EVIDENCE FOR

~~SUBMISSION TO~~ THE ROYAL COMMISSION OF INQUIRY:

AN ALTERNATIVE COLLAPSE SCENARIO FOR THE CTV BUILDING

John B. Mander PhD, F.IPENZ

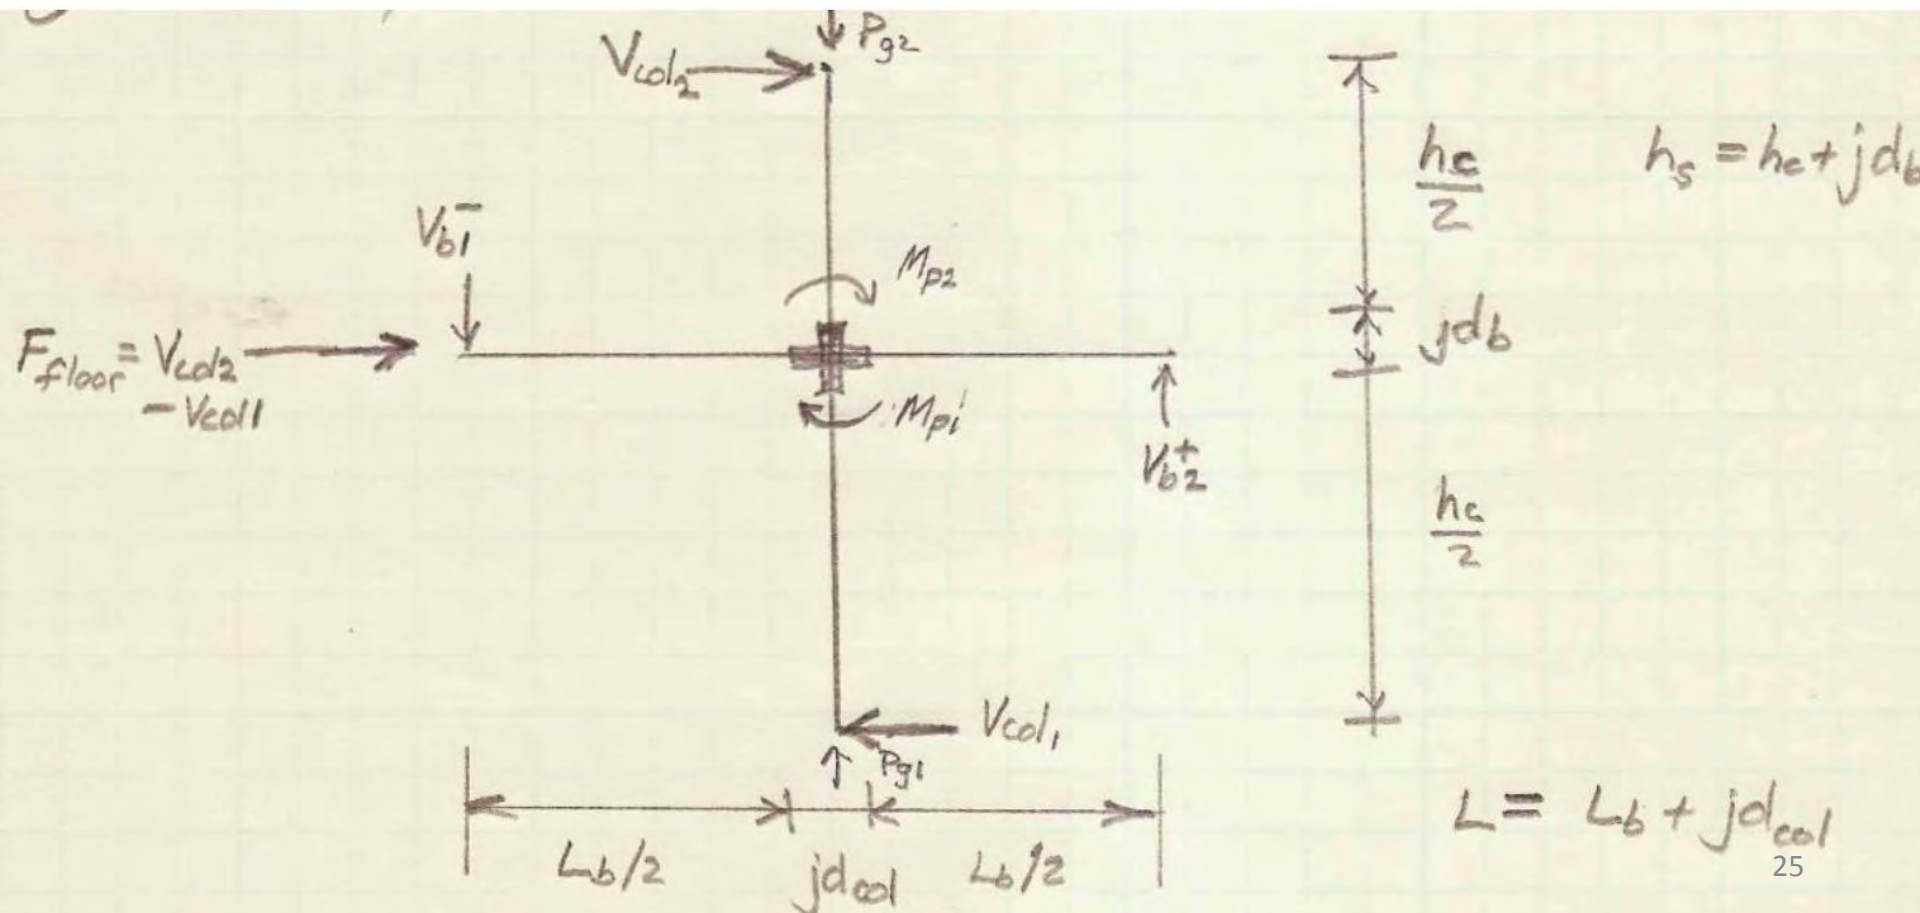
Normal capacity design

desired strength hierarchy
(from weakest to strongest)

1. Beam bending (flexure)
2. Column bending/flexure
3. Joint shear
4. Foundation capacity

CTV Building

under an E-W sidesway
(from weakest to strongest)

1. Joint shear
2. Column flexure
3. Beam flexure
4. Wall Capacity or
foundation rocking

Fig 2.10. The modified sidesway mechanism arising from the presence of "weak" beam-column joint regions

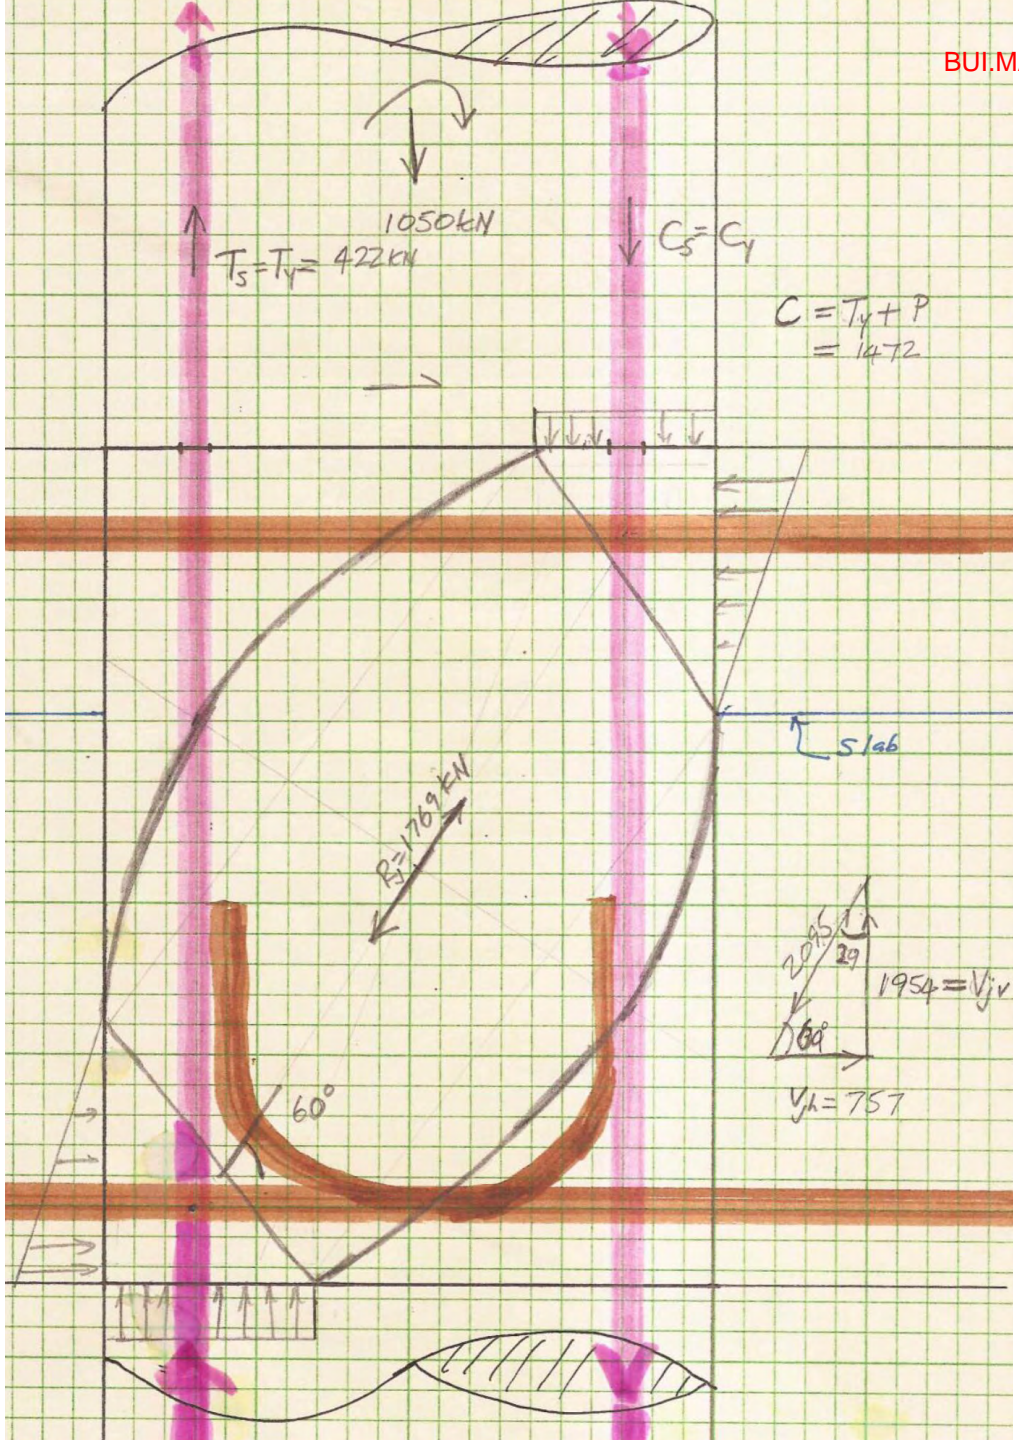
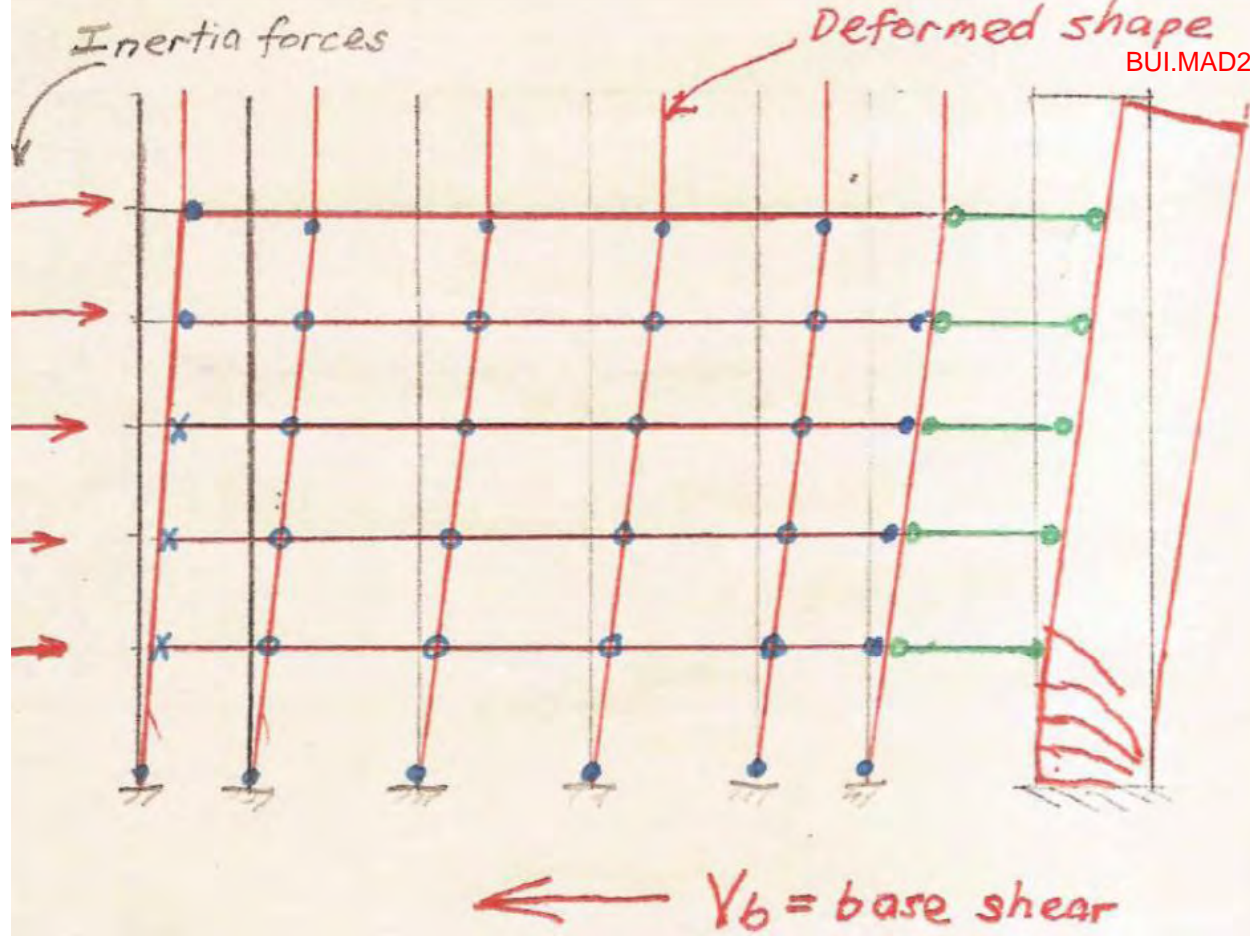
- Plastic hinge zones at member ends
- X Failed plastic hinge zone through joint pull out
- Beam-column joint regions where the joints are weak in shear or failed in shear trying to resist high column and beam moment effects.
